<b>Office Action Summary</b>	<b>Application No.</b>	<b>Applicant(s)</b>	
	10/566,455	PATHAK ET AL.	
	<b>Examiner</b>	<b>Art Unit</b>	
	Alfred Joseph Wujciak III	3632

This is the final Office Action for the serial number 10/566,455, VEHICLE SEAT ASSEMBLY AND FLOOR RAIL FOR LATERAL SEAT SHUTTLING, filed on 1/30/06.

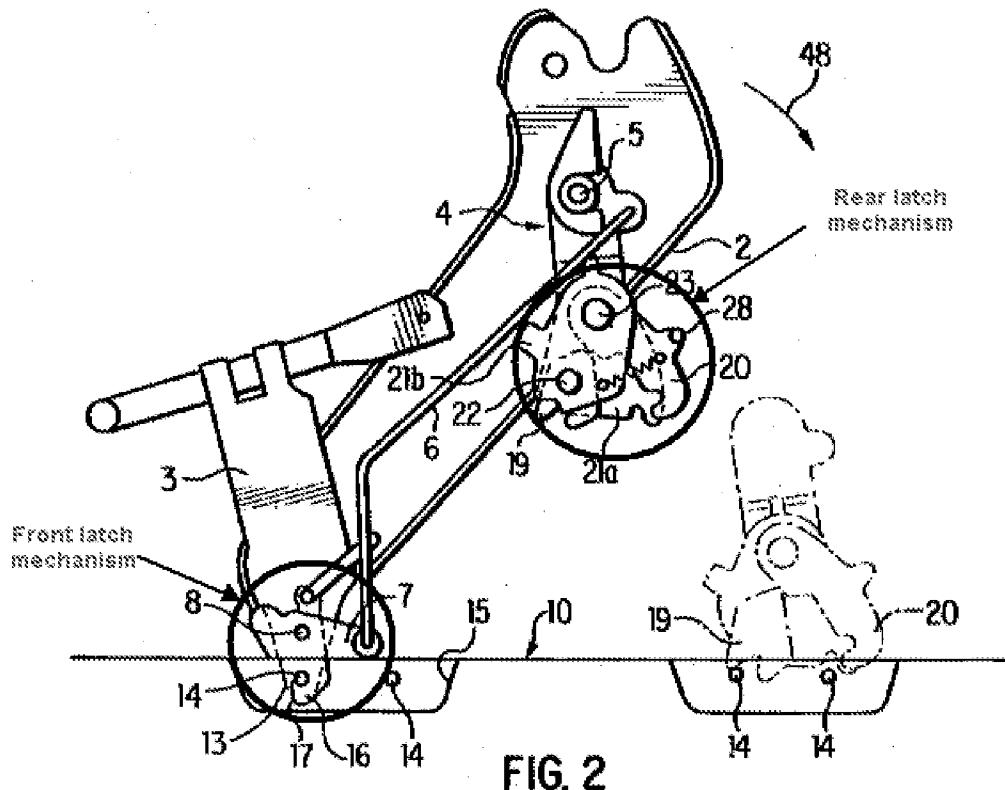
Chabanne teaches an assembly comprising a front latch mechanism having a support plate (7) and a rear latch mechanism having a mounting plate (21a) and a pair of opposing front (19) and rear (21b) latch plates independently pivotally coupled to the mounting plate. Each of the pair of opposing front and rear latch plates selectively engage the rear slide rail. The assembly includes a release cam member (27) operatively coupled between the pair of opposing front and rear latch plates.

The applicant states "The '596 reference does not disclose a pair of opposing front and rear latch plates independently pivotally coupled to a mounting plate, as specifically required by claim 8 in the above captioned application." The examiner disagrees with the applicant because '596 reference shows a pair of opposing front (19) and rear (21b) latch plates independently

pivots coupled to a mounting plate (21a). The specification in '596 reference, column 2, lines 66-67, states "the front catch 19 is articulated about a pin 22" and column 3, lines states "21b is mounted articulated on the pin." The mounting plate 21a provides pins (22-23) for the front (19) and rear (21b) latch plates to pivot independently on the mounting plate.

The applicant states "Further, the '596 reference does not disclose a release cam member operatively coupled between a pair of opposing front and rear latch plates for simultaneously engaging and pivotally releasing the pair of opposing front and rear latch plates from engagement with a rear slide rail, as specifically required by claim 8 of the above-captioned application." The examiner disagrees with the applicant because the release cam member is located in between the opposing front and rear latch plates and the cam member engages the front latch plate which engages the rear latch plate by spring (column 3, lines 20-33). The front latch plate with spring connected to the rear latch plate has the ability to control the rear latch plate once the cam moves the front latch plate. Therefore the cam has the ability to move both front and rear latch plates.
